**Officer Update Note
30th June 2021**

Item 5.1

APPLICATION NUMBER:	2021/0129/S73	PARISH:	Little Fenton Parish Council
APPLICANT:	Mr and Mrs Watson	VALID DATE: EXPIRY DATE:	2nd February 2021 30th March 2021 (EoT 14 th May 2021)
PROPOSAL:	Section 73 to vary/remove condition 02 (approved plans) of planning permission reference number 2019/0578/FUL proposed conversion of ancillary building to dwelling granted on 5 March 2020		
LOCATION:	Willow Barn, Sweeming Lane, Little Fenton, Leeds, North Yorkshire, LS25 6HF		
RECOMMENDATION:	APPROVAL

Photo provided by the Objector

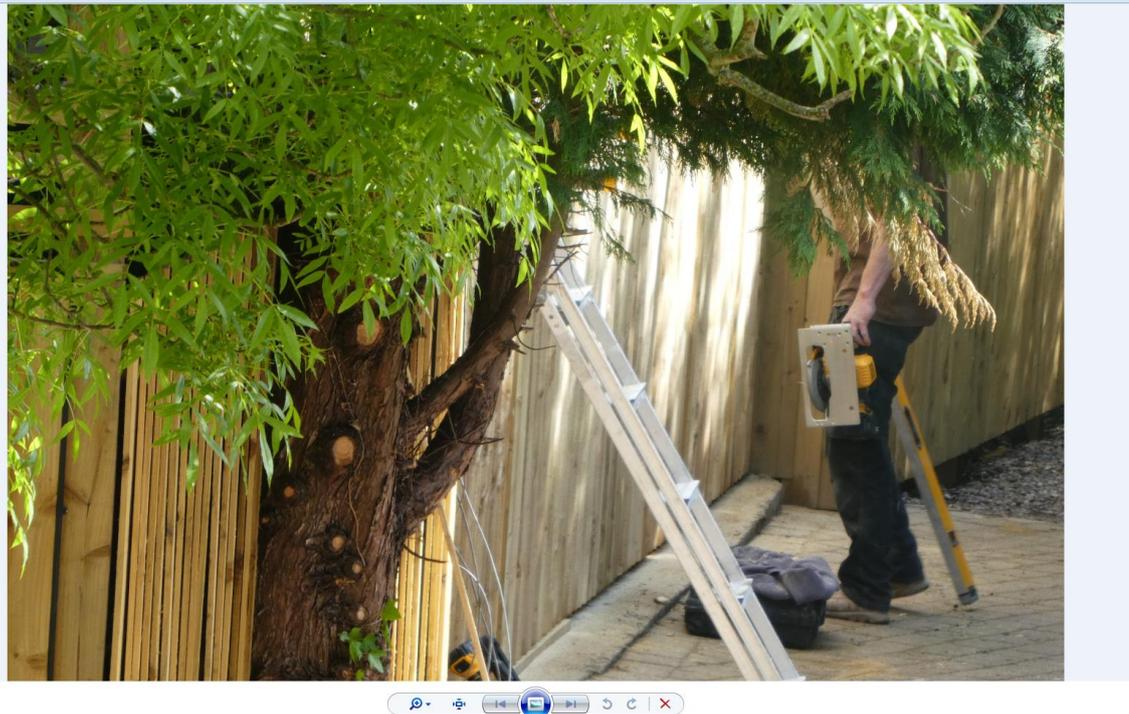
<p>Please can you confirm which skin of blockwork that this photograph shows the cladding being affixed to. The inner skin of blockwork, or the outer skin of blockwork</p>	<p>The Officers view of the photograph is that work was been undertaken to the western elevation in the photograph (see below). As the outer skin is still in place on this elevation then it would seem that the work is being done on the outer skin.</p>
<p>Please confirm why there is no mention of this continued building work included in your report and the applicants have continued to work on site.</p>	<p>Officers did contact the Applicants and sort confirmation that no further work would be undertaken on site following the email from the objector on the 18th May 2021. This is not a fact that needed to be reported to Committee as the application is a S73 and the Applicants confirmed that work would cease. As requested by the Objector the photograph provided to us on the 18th May 2021 is included below.</p>

Drawing 2781-02--04B Current Works on Site

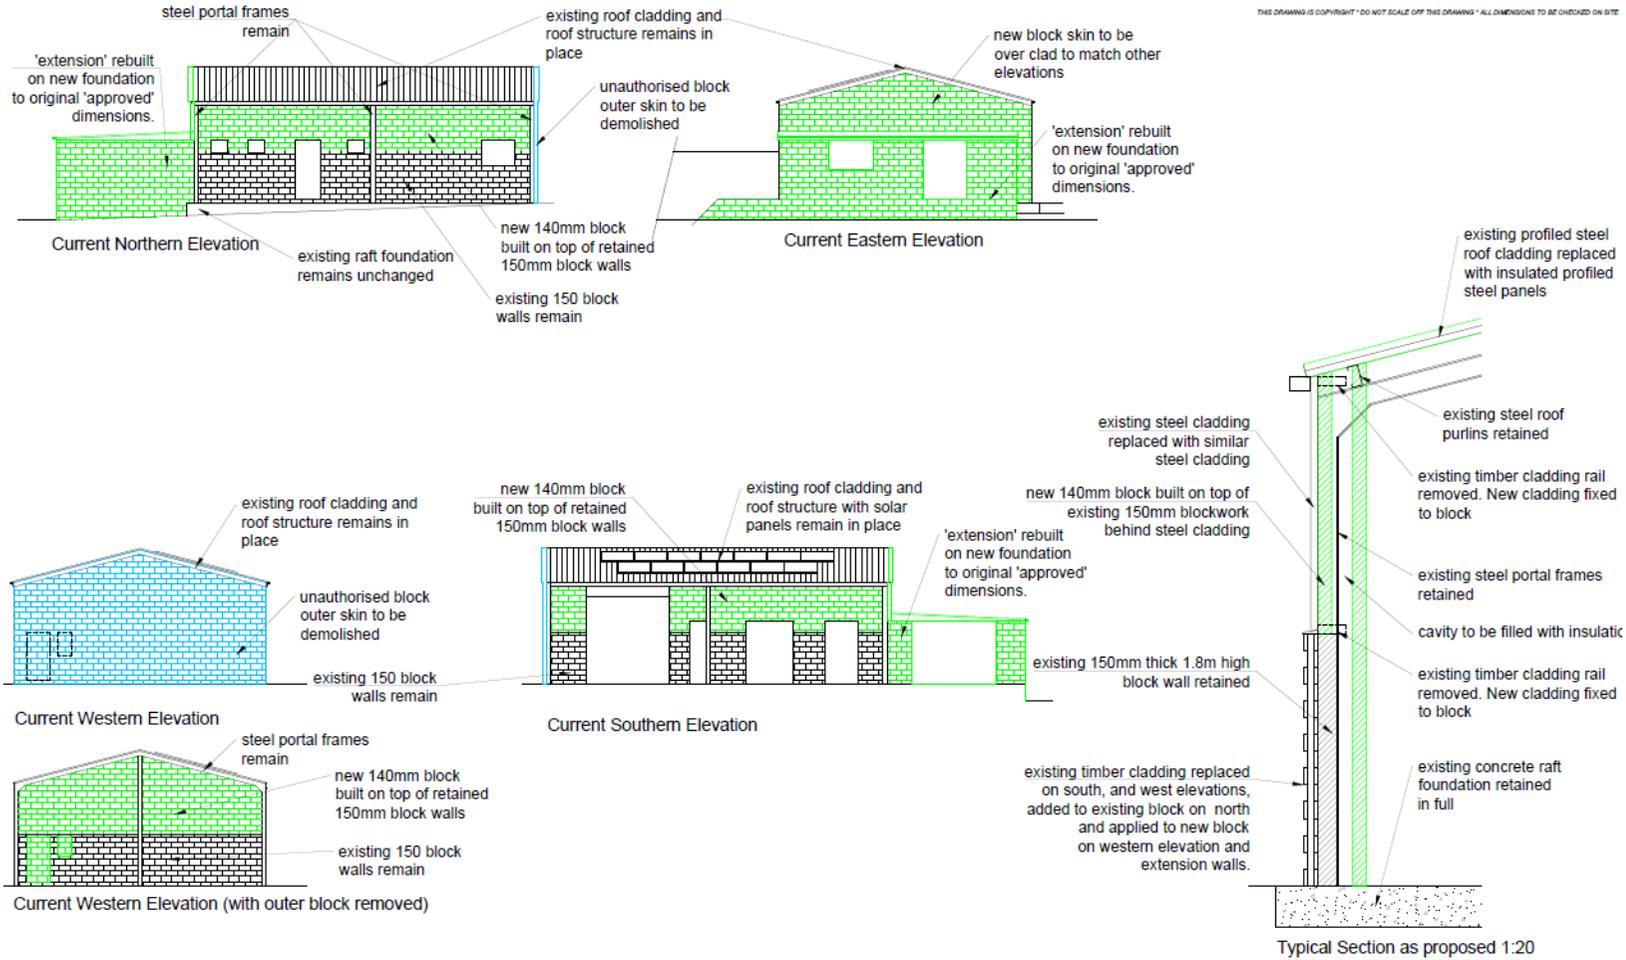
<p>It is noted that a new drawing was submitted today (29th June 2021). This drawing shows a contradiction in terms of roof cladding, but whilst we appreciate that this is “current site works drawing”, but it is the only drawing that shows more specifically the roofing proposed. On the Current Easting & Northern elevations, and also the western elevation, it states that the “Existing roof cladding and roof structure remains in place”, however on the Typical Section it states “existing profiled steel roof cladding replaced with insulated profiled steel panels”. The Typical Section detailing will lift the roof height, as it is proposed to be a thicker insulated panel, plus purlins on top of the portal</p>	<p>The drawing was revised on the 29th June 2021 to clarify the block width for the internal walls as there was inconsistency on the drawing.</p> <p>The Elevations on Dwg 04B show the current buildings on site so they are correct and accurate.</p> <p>The Cross Section shows the approach to the roof and the external materials.</p> <p>The proposed Condition 7 requires agreement of the final materials and as noted in the Officers Report the material mix noted on Drawing 04B are acceptable subject to final finish and colour.</p>

There has been an update to Drawing 04A, in terms of the annotations pertaining the block widths for the internal wall structures and the replacement outer block sections to ensure these are consistent and accurate. As such the reference would now be **Drawing 2781-02-04B** within proposed **Condition 1** accordingly. A copy of this drawings is attached to this update note.

The Elevations on this drawing were provided by the Applicants to show what is currently on site and not what is proposed on site and this information was provided to allow Members to understand what has been constructed on site,

The “Typical Cross Section” does include reference to the works that are to be done including

- a) the existing steel roof cladding is to be replaced with “insulated profile steel panels;
- b) that timber cladding will be added to bottom section of the elevations; and
- c) that steel cladding will be added to the upper sections.

Rev A 1/9/21 New Block on section revised to 140mm (from 100mm).

Drawing 2781-02--05 Block Work Calculations

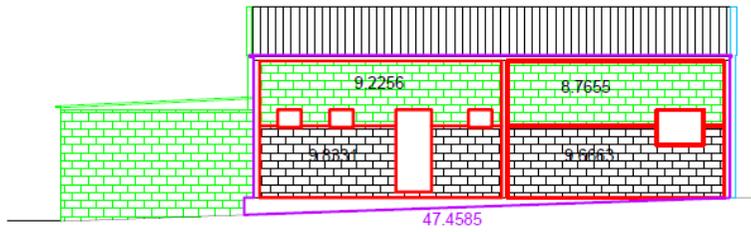
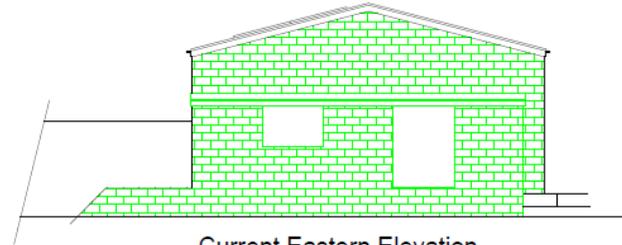
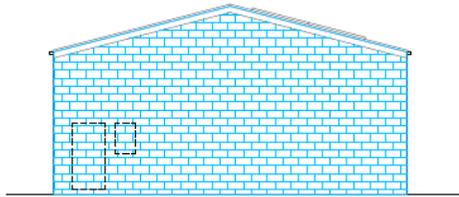
Comment	Officer Response
Section 5.3 notes that <i>“the applicants have now removed the majority of the external blockwork outer leaf”</i> . Please can you confirm, by way of a percentage calculation, what percentage of the blockwork constructed without consent, that which is over and above the original single skin of blockwork that was up to 6ft in height, and now currently remains in place today.	The information provided by the Applicants on the 1 st June 2021 clearly shows that the only remaining “external blockwork” is that on the western elevation, as shown in blue. This is 100% of the western elevation but this has been confirmed as to be removed.
<i>Section 5.3 states that “. . . and reinstated the upper sections of blockwork” please can you confirm which parts of the blockwork you claim has been removed, and have been re-instated. Re-instated would be that which was built (without permission), removed (as you state has occurred), and then re-instated (again this would require building without permission). A percentage calculation will suffice.</i>	The information provided by the Applicants on the 1 st June 2021 clearly shows those elements that have been rebuilt. A further drawing has been provided showing the calculations of the in terms of the square metre areas for the blockwork by elevation and confirming what percentage is existing and new. A further figure has also been provided confirming the percentage based on the whole elevation not just the blockwork. This is shown on Plan 2871-02-05 as attached to this update note. The data on the drawing is as follows

existing	new	total (block)	% new (block)	area of whole elevation	% new block of whole elevation	
	west	14.03	19.38	33.41	58.00	38.95	49.76
	south	9.71	13.14	22.85	57.51	44.73	29.37
	north	19.50	17.99	37.49	47.99	47.46	37.91
Please can you confirm to committee which is the only Condition this 2021/0129/S73 application is seeking to discharge, and what is this limited to.	A Section 73 submission is not a submission to discharge a condition it is a submission to vary. remove a condition. In this instance the submission is to vary the plans approved and those noted in Condition 2 of the original permission.						
Please confirm to the committee members the original approved form of construction, and where in the original application document these can be found, as they are not on the list of drawings included in Condition 2.	A drawing was submitted with the original application (Ref 2019/0578/FUL) showing that an inner skin would be constructed and this was referenced in the Committee Report.
